# RotorSport UK Ltd Service Bulletin (Permit)

<b>Title: IVO-prop motor housing nut torque</b>		
<b>SB-126 Iss1</b>	<b>Related documents</b> Modification: MC-276, -294, -318, -323 CCAR No.: CCAR-64, -66, -70	<b>Compliance Category:</b>  <b>OPTIONAL</b> <del>or</del> <b>RECOMMENDED or</b> <b>MANDATORY</b>
<b>Applicability</b>		
<b>Aircraft type &amp; model:</b> Any RSUK type fitted with IVO-prop DL3-68 VP-propeller	<b>Aircraft serial Nos. affected:</b> Any RSUK type fitted with IVO-prop DL3-68 VP-propeller	
The maintenance manual to be referenced is this stated or subsequent issue.		MT-03 RSUK0012 Iss 10 MTOsport RSUK0044 Iss 9 Calidus RSUK0061 Iss 7 Cavalon RSUK0288 Iss 5
<p>This form is the response from RotorSport UK Ltd either against a problem found in the product in service requiring a containment or rectification action, or as service information for aircraft modification incorporation. For help, contact RotorSport on 44(0)1588 505060, or email <a href="mailto:compliance@rotorsport.org">compliance@rotorsport.org</a>.</p> <p>The technical content of this document is approved under the authority of the UK CAA Design Organisation Approval Ref: <b>DAI/9917/06</b></p>

## **Reason

Motor/gearbox assembly removed. Adjust these three nuts.

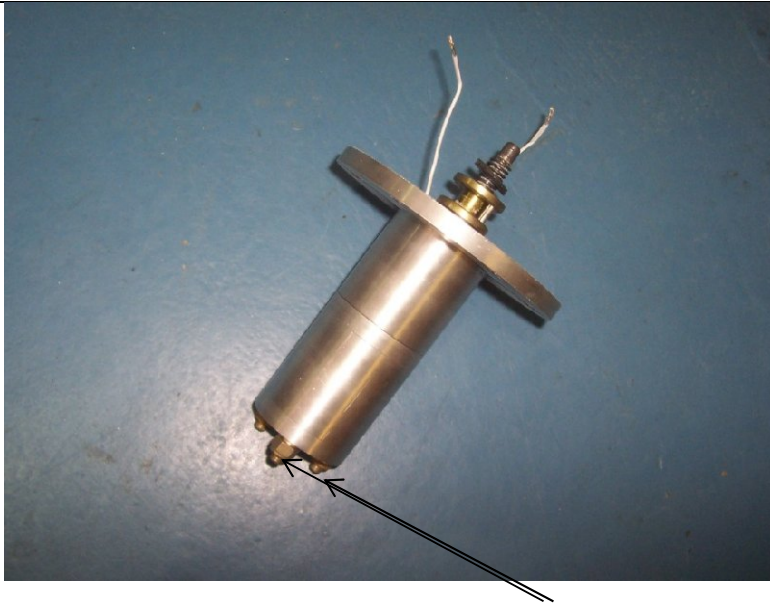
- The tightness of the three nuts at the end of the gearbox assembly can adversely influence the axial load incurred by the internal thrust bearings, leading to premature wear and excessive current draw by the motor.
- The grease used by the OEM is better replaced by a Molykote type grease

5. Using a 1/2"AF spanner progressively release the three nuts.
6. Progressively tighten these 1/2"AF nuts to 10Nm (tolerance 10-15Nm) only.
7. Suitably mark the rear motor face of the motor housing to denote the nut torque has been adjusted.
8. Following safe practice a qualified gyroplane pilot or appropriate person must ground-test the propeller in accordance with the instructions in the Pilots Handbook, to demonstrate proper function to pitch limit stops.
9. If satisfactory, refit the spinner (if fitted) in accordance with the aircraft AMM. Otherwise repair in accordance with the propeller handbook.
10. Update aircraft and propeller documents accordingly.
